To: Salt Lake City Planning Commission  
From: Daniel Echeverria, (801) 535-7165, [Daniel.echeverria@slcgov.com](mailto:Daniel.echeverria@slcgov.com)  
Date: June 4<sup>th</sup>, 2015  
Re: Bishop Place Planned Development Approval Time Extension Request

The Bishop Place Planned Development (PLNSUB2014-00020) received Planning Commission approval on June 25<sup>th</sup>, 2014. Since that time, the applicant has submitted remodeling plans for some of the involved homes for Historic Landmark Commission review and has received a few approvals for those plans. They have also submitted a final subdivision plat for City department reviews and are currently working through that process in order to obtain final City department approvals for the subdivision. The developer has also noted in their request letter ([Attachment A](#)) that they have been working with other agencies to obtain development approvals.

To: Salt Lake City Planning Commission  
From: Daniel Echeverria, 801-535-7165, Daniel.echeverria@slcgov.com  
Date: June 18, 2014  
Re: PLNPCM2014-00021 432 N 300 West Zoning Amendment; PLNSUB2014-00019/00020 Bishop Place Planned Development and Subdivision

**BISHOP PLACE**

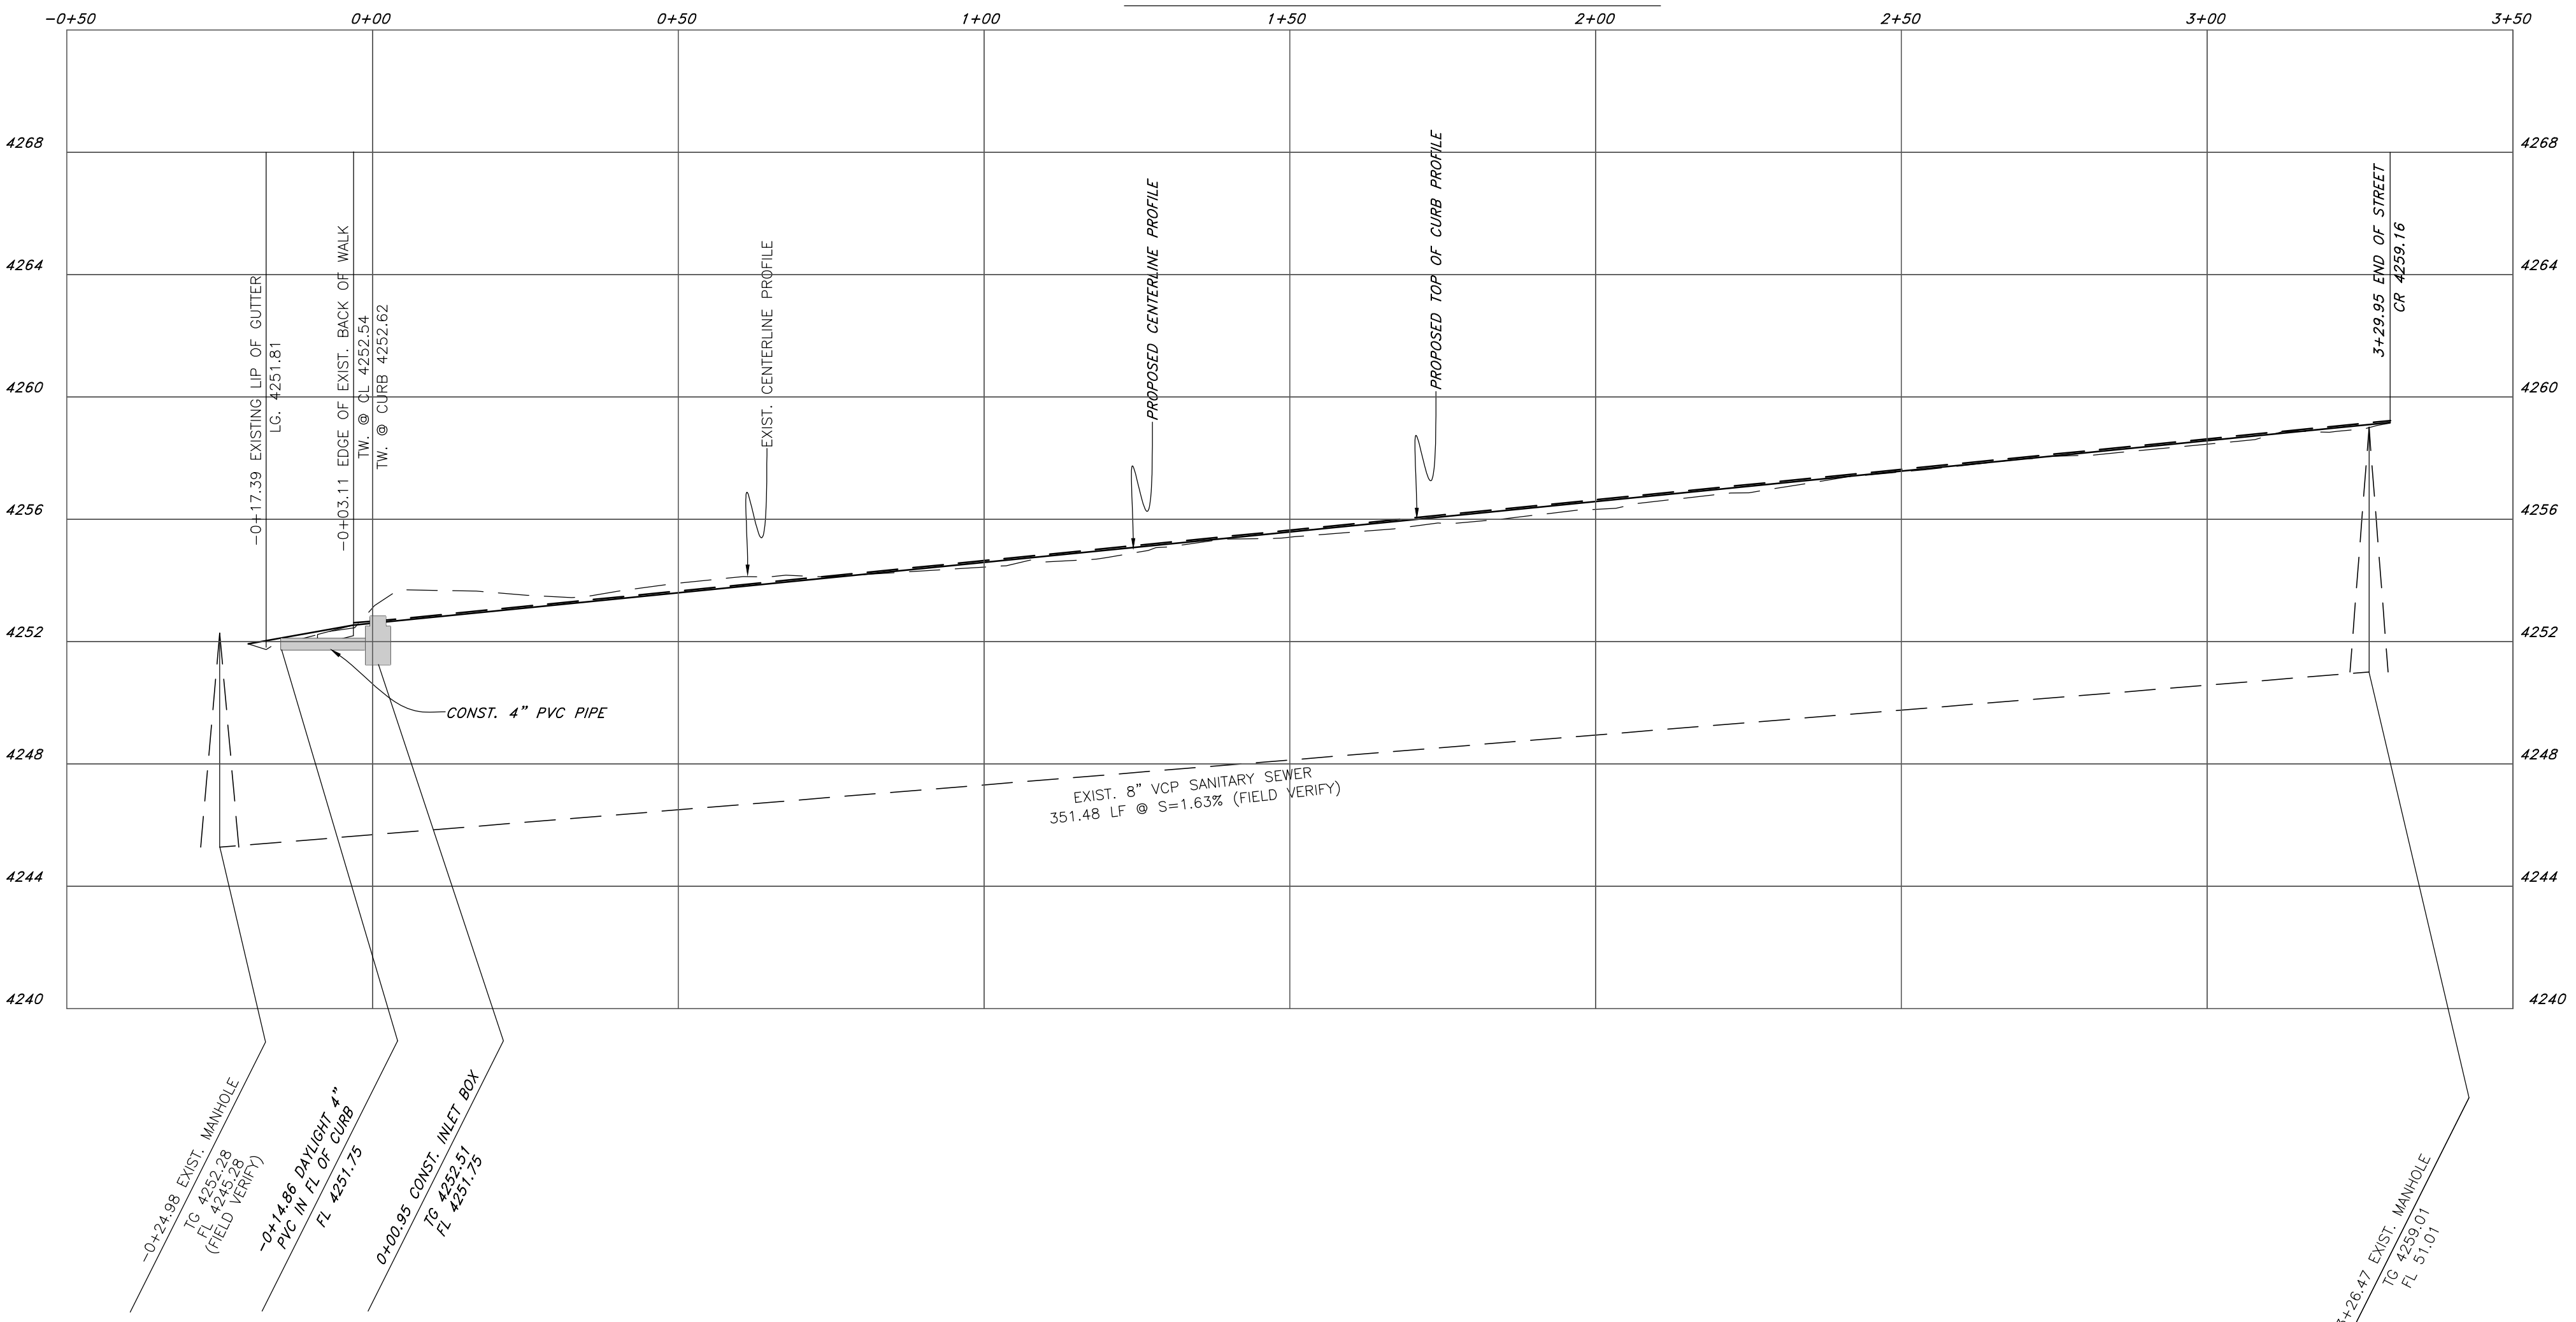
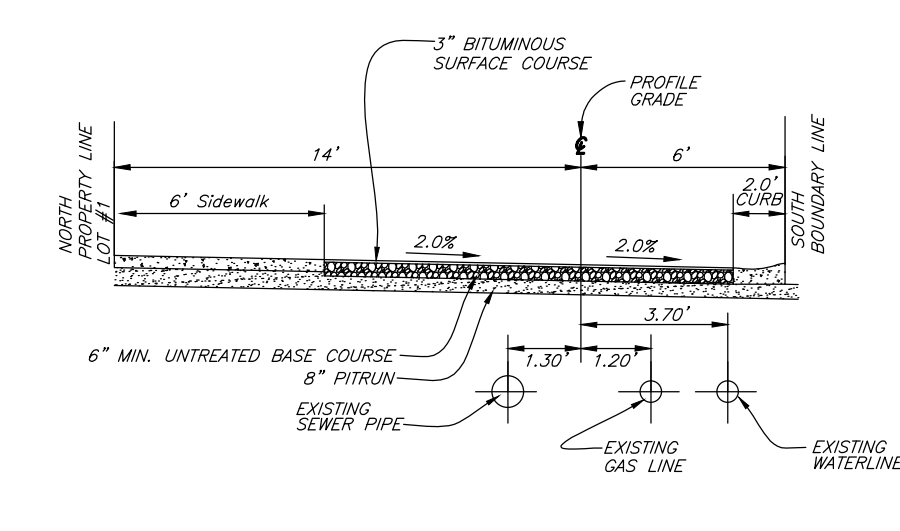
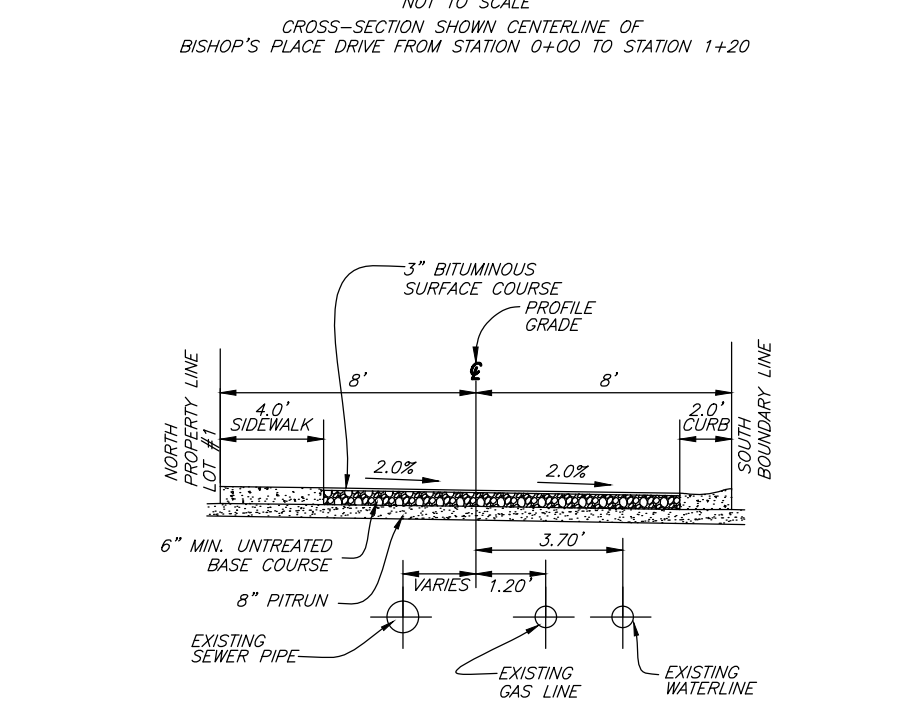
Normally, the street would need to be at least 20' in width and have a fire vehicle turnaround to meet Fire Code standards. However, 20' of width is not available for the entirety of the street and so the normal Fire standard cannot be met. Due to this limitation, the applicant is proposing to provide fire protection with fire sprinkler systems for all homes to the east of the 18' wide portion of the street. The Fire department accepted the proposal and is modifying the requirement for a full size emergency vehicle turnaround and 20' of street width on the condition that fire sprinklers are installed in these homes and that the sprinklers are inspected annually.

The proposed street was reviewed by the Streets department, which is responsible for snow removal. The Streets department indicated that although a "T" type turnaround at the end of the street would be preferred, their smallest snow removal vehicles can turnaround within a 20' street width. They note that if there is just one car parked on the street, snow removal would not be possible. In response to the turnaround recommendation, the developer is proposing a semi-circular turnaround at the end of the street with a width of 37' at the widest point to accommodate the turnaround of snow removal and other larger vehicles. This reduces the potential for property damage from vehicles to the homes that directly abut the street.

Here is our input on this subject after the recent proposed modifications. As far as hauling snow goes we only provide that service in extreme conditions and typically from down town only. The normal operational approach is to let warmer temperatures melt it away and that way we do not have to load and unload sanders and burn extra fuel. Based on Michael's experience 20 feet is adequate to turn around our smallest snow removal vehicle (F550) that we have to use on this location. You questioned backing in or out of this section. It is a safety item for us. Under possible dark icy conditions we rather not have to back our vehicles whenever possible. One important point is that even though there would be no parking allowed anywhere on this street even if there is one car parked there we would not be able to provide snow services.

The issues with turning around would be better resolved if the street had a "T" at the end. There are a couple of streets like this in the city and it works. The only other issue I can think of from my perspective is who is going to remove the snow that piles up at the end of the street? We typically do not have a free truck in the winter to haul snow away. If we unload a trucks to haul salt or snow, we could possibly do it then. 20' would be adequate to turn a F-550 around too.

It is extremely narrow where you enter off of 300 West. The turn is extremely tight and is on a (busy at times) roadway. There is an existing business on the south side where Bishop Place starts that is right up against the road. There is no buffer to avoid hitting the building, and this seems to be the most narrow part of the street. There may be room to widen this portion if the large trees on the north side are removed. There is really nowhere to push the snow on either side, not even a sidewalk right now, however I would think some sort of walkway is planned. There needs to be an area at the East end to turn around. At this time it is a very blunt "Dead End" street. In order to plow it, we would have to back down or back out. Both of these options would have us backing and stopping on 300 West which can be very dangerous. As it sits now, the service level will be provided by a F-550, and I see no way that another form of snow removal would ever be possible. My final observance is that if parking is allowed on this street during storms, plowing may be rendered impossible.

Staff recommends approval of the reduced public street width dedication as part of the Planned Development and Subdivision on the condition that the requirements by the Transportation, Fire, Public Utilities, and Engineering departments are met. These requirements may result in some slight modifications to the final street configuration for technical or engineering considerations, but the general configuration of the surrounding private property development will remain the same.

***Planning Staff Note:*** In reponse to these comments, the applicant is installing a 37' wide turnaround on the street to accommodate snow removal vehicle turnaround.
